SERVICE BULLETIN

Service Bulletin No.: DAC1-92-06, Rev 0

Title: Night VFR Requirements for Operation in EASA Member Countries

Figure 1 - Exterior Canopy PLacards Installation

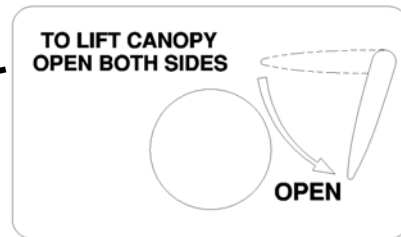
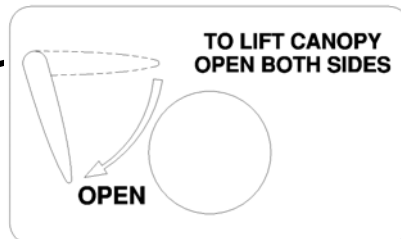
- 10.1 Replace the following standard English placards with illuminated English placards as shown in Figures 1 through 4. Refer to Aircraft Maintenance Manual DA201-C1 for the instructions to remove and re-install the canopy lock and canopy handles.
